**SERVICING DESIGN BRIEF
AND
STORMWATER MANAGEMENT
REPORT**

1420 EARL ARMSTRONG ROAD

TOWN SQUARE CENTRE

**SITE PLAN APPLICATION
FILE No. DO7-12-14-0067**

**EXTERNAL STORM DRAINAGE AREA
 AND OFF SITE DITCHING PLAN**

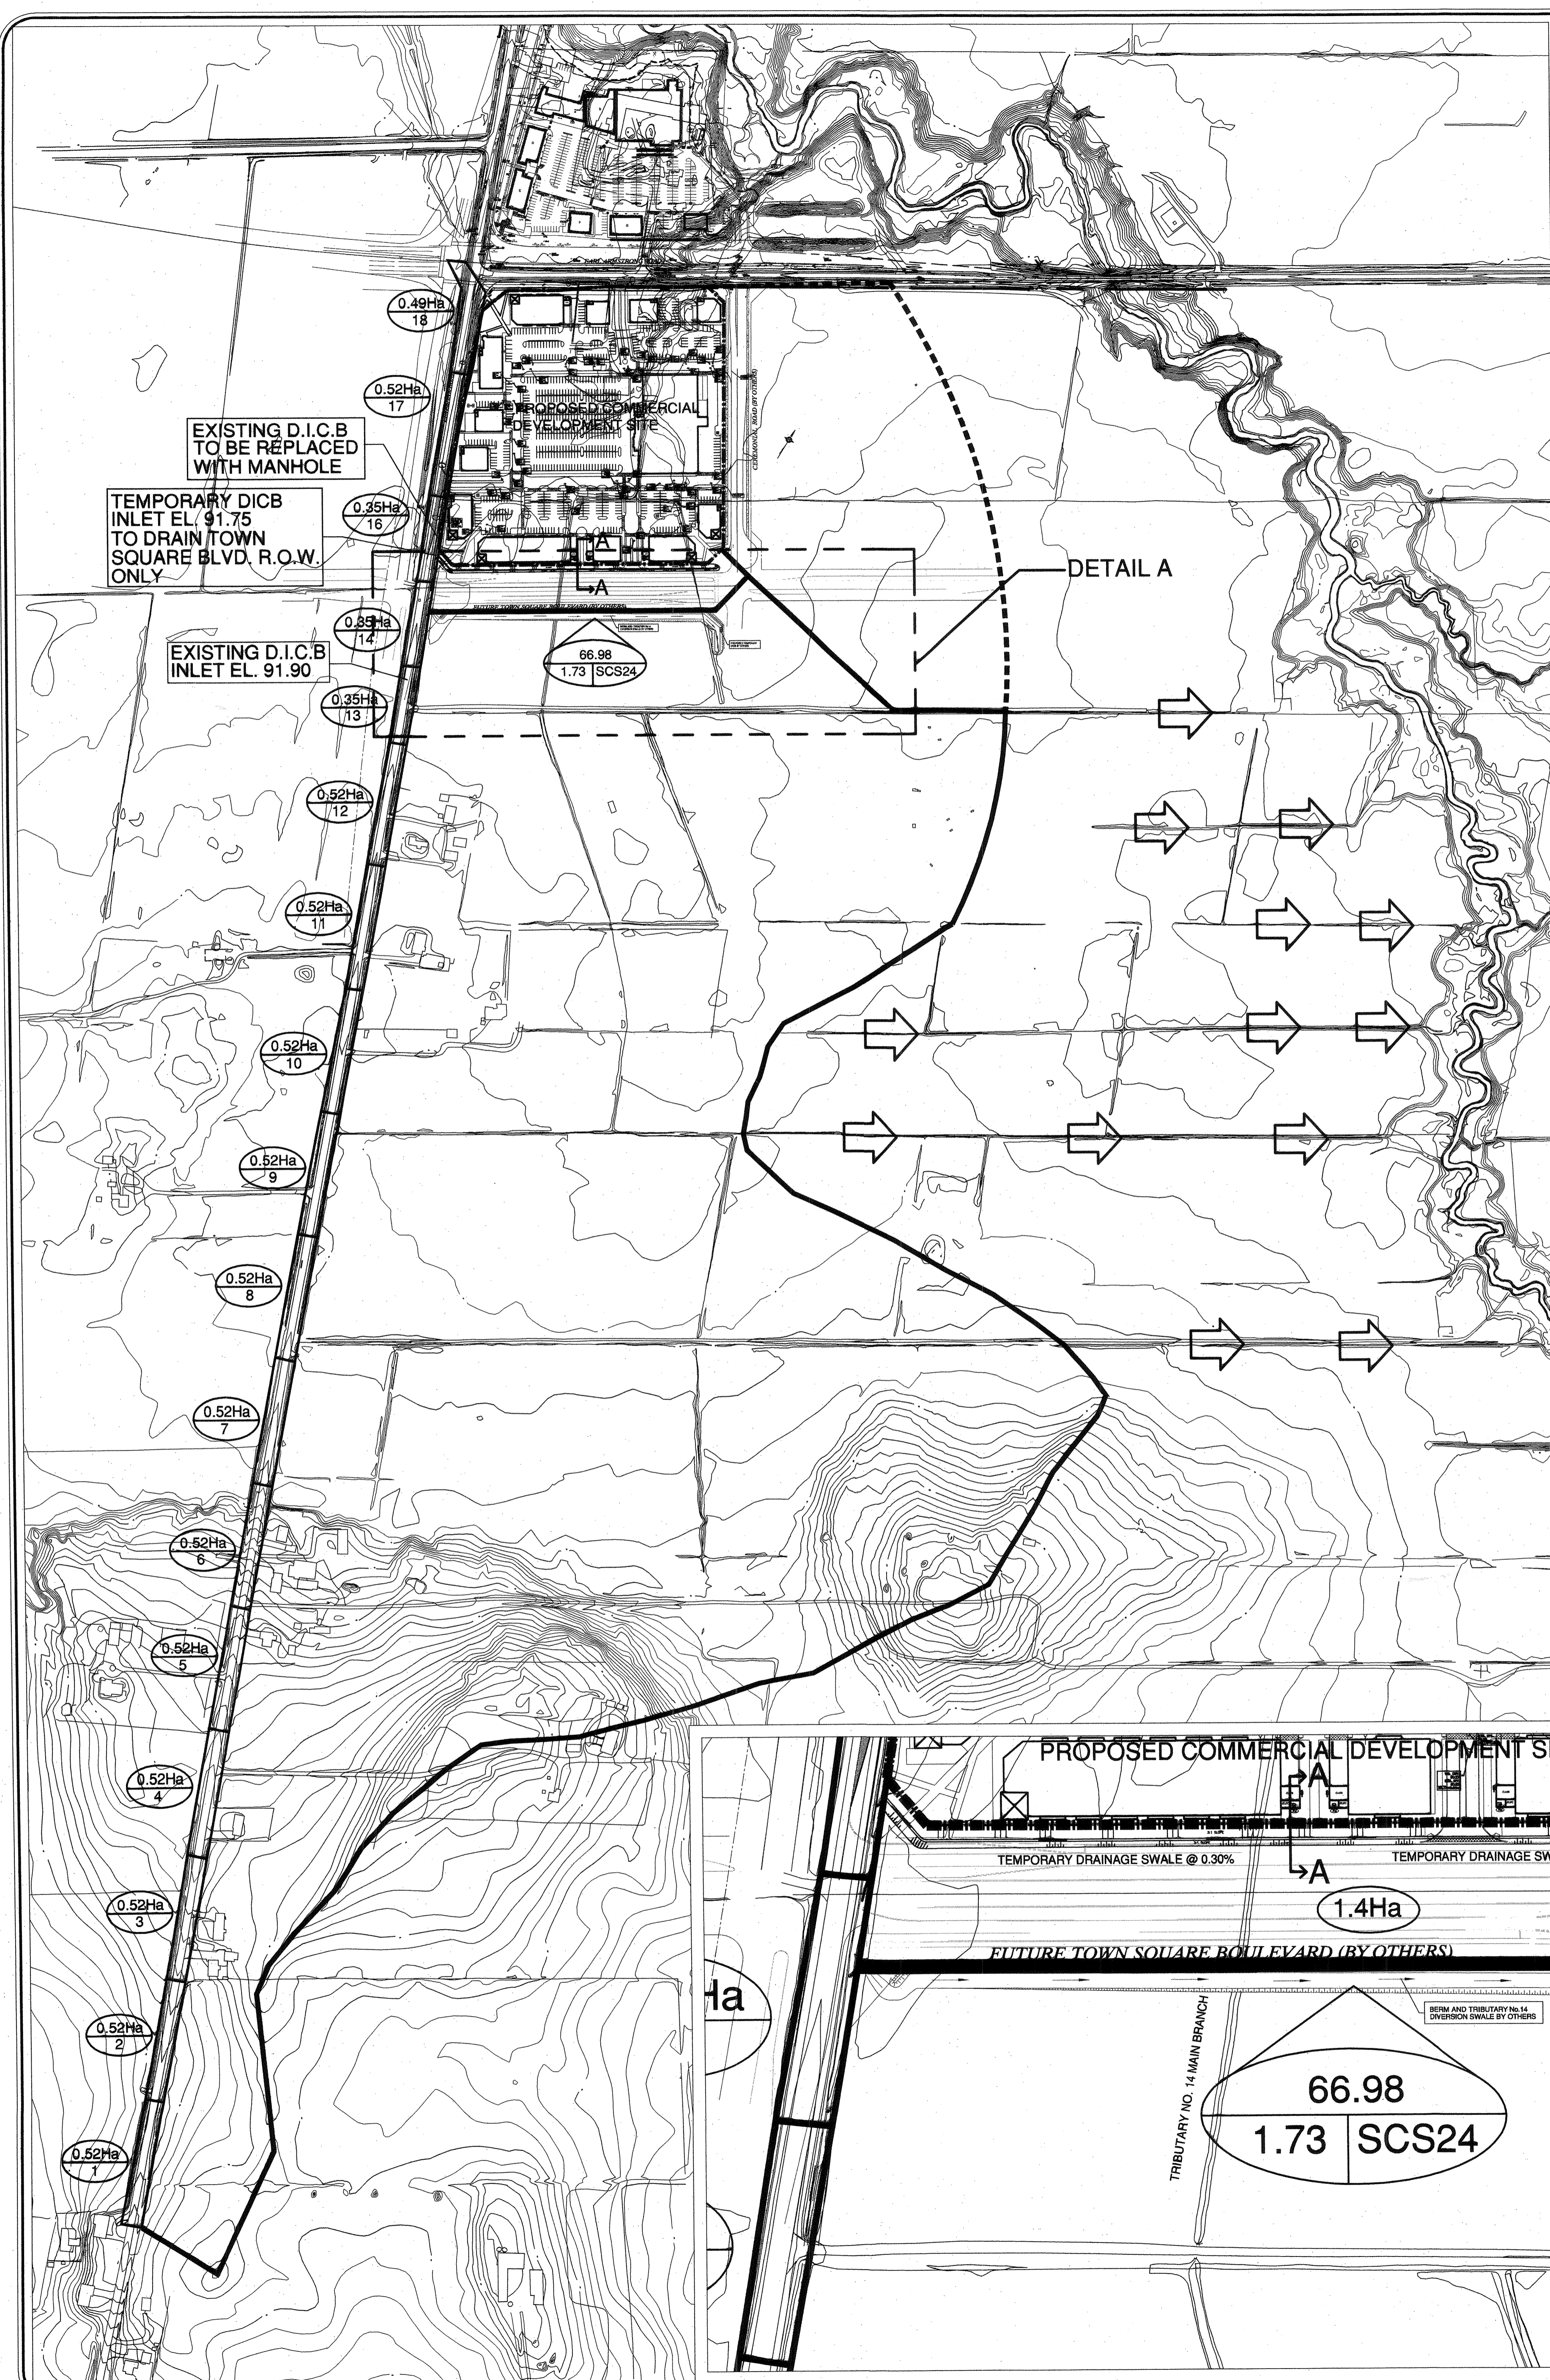
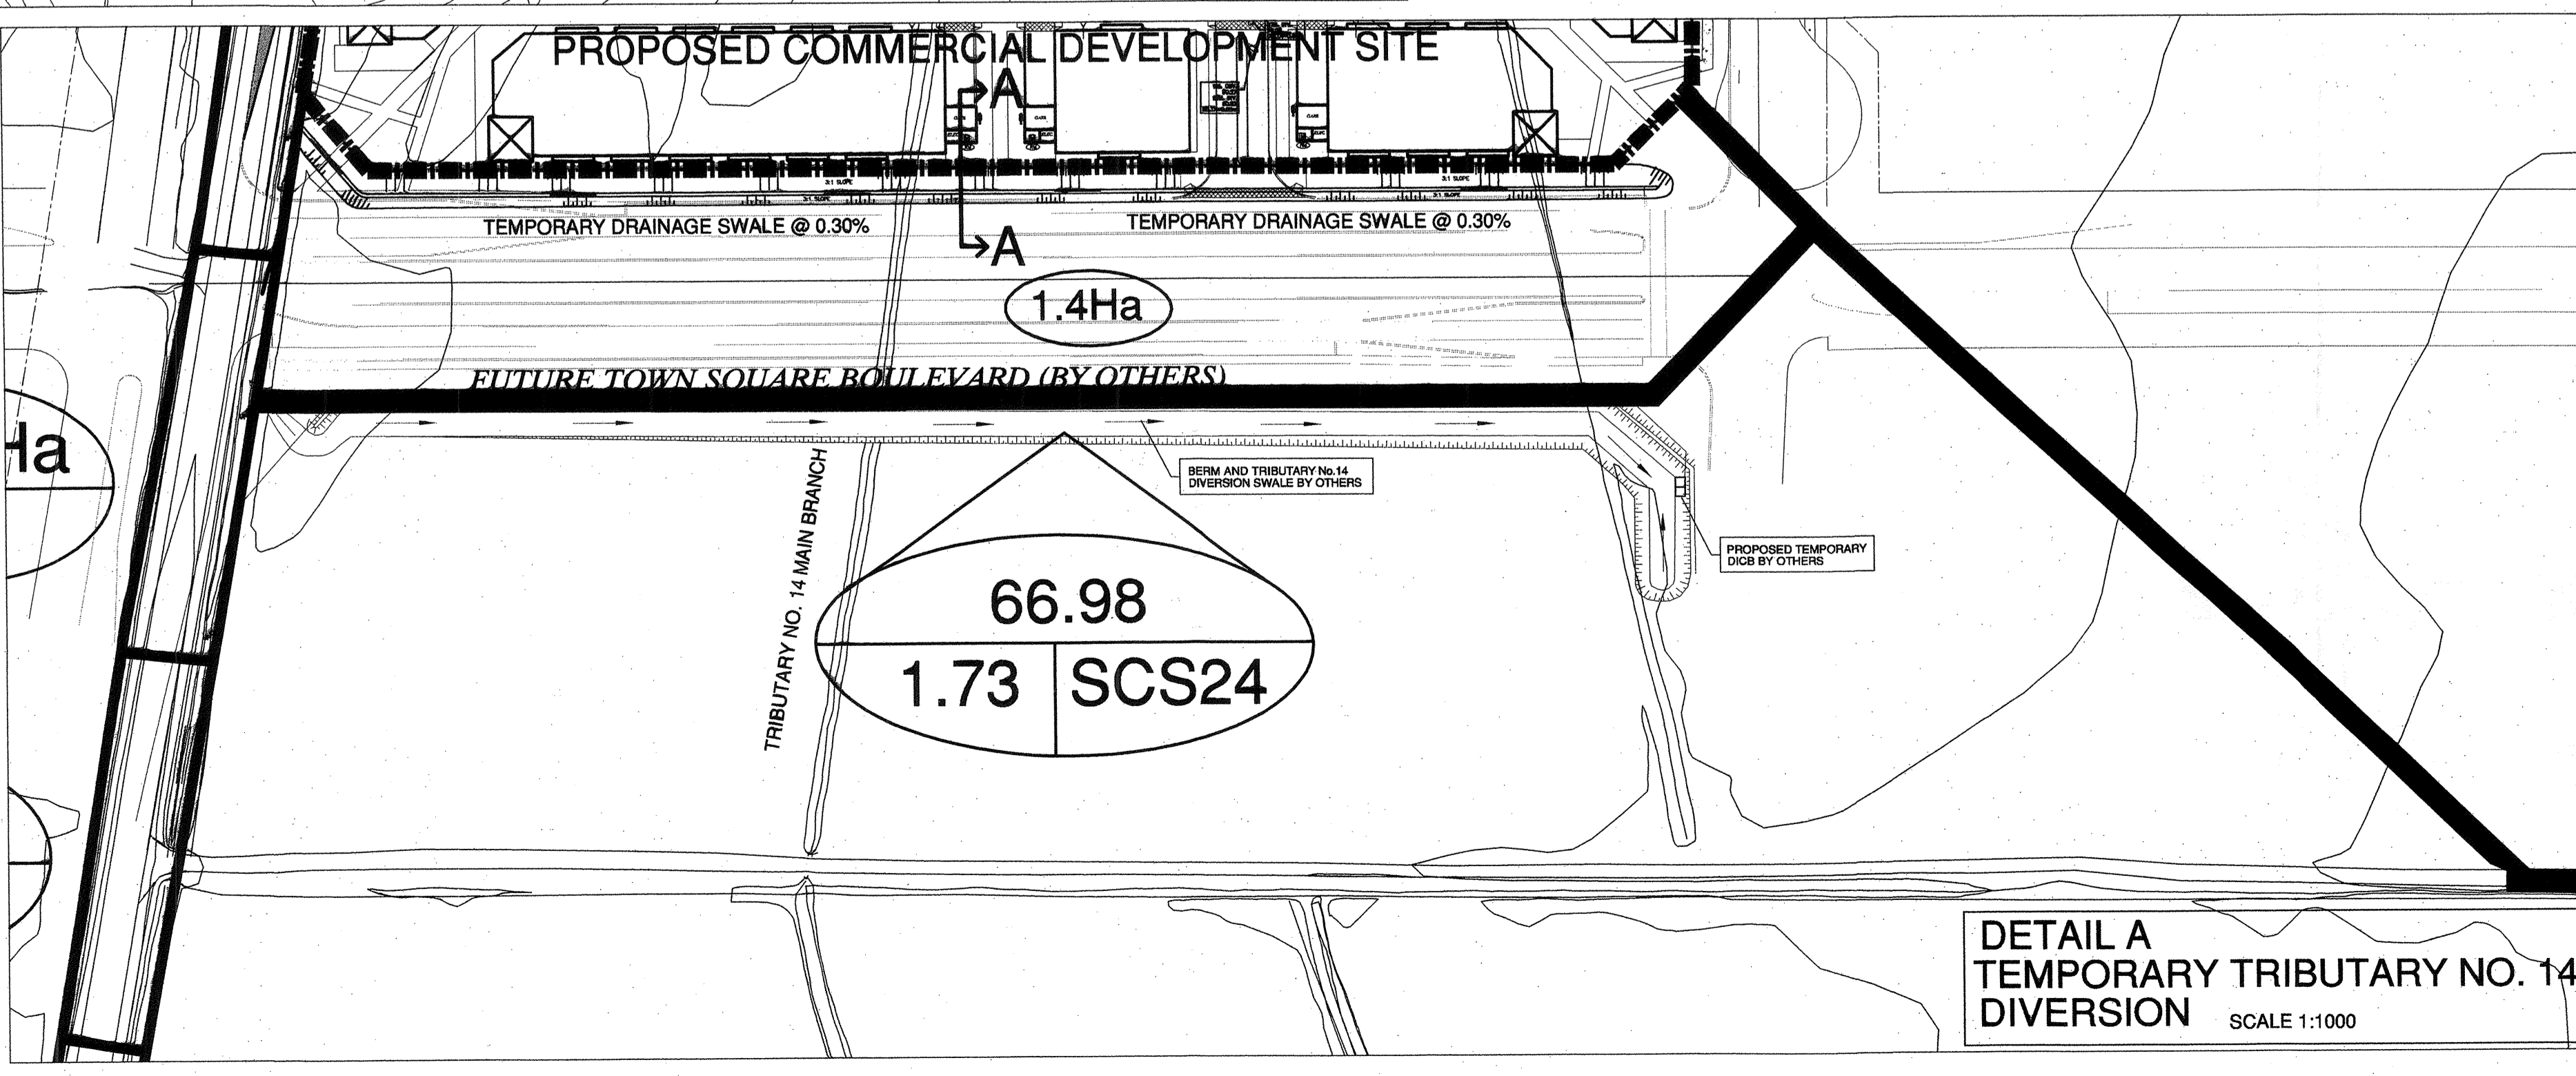
92. See comment on Dwg 4 of 8 regarding identifying which drawing to be used for off-site ditch construction detail

Response: *Noted*
